DEPARTMENT OF TRANSPORTATION

Federal Aviation Administration

[Docket No. 83-ANE-14-AD]

Airworthiness Directives; Hartzell Propeller Inc. (formerly TRW Hartzell Propeller) Model HC-B3TN-2, HC-B3TN-3, HC-B3TN-5, HC-B4TN-3, HC-B4TN-5, HC-B4MN-5, and HC-B5MP-3 Turbopropellers

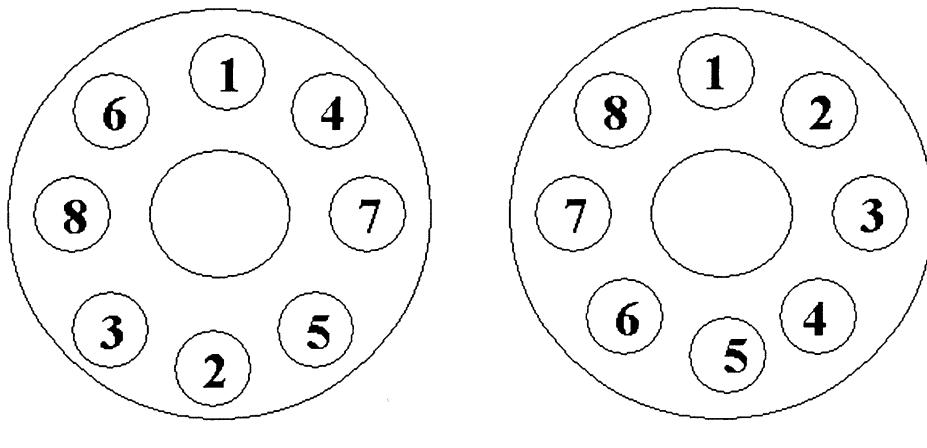
(5) Torque all attaching bolts with a torque wrench and an appropriate adapter, to 40 ft.-lbs., and then to 80 ft.-lbs. Following sequence "A" (shown below). Final torque all attaching bolts using sequence "B" (shown below) to 100 to 105 ft.-lbs. Safety wire all attaching bolts in an FAA-approved manner.
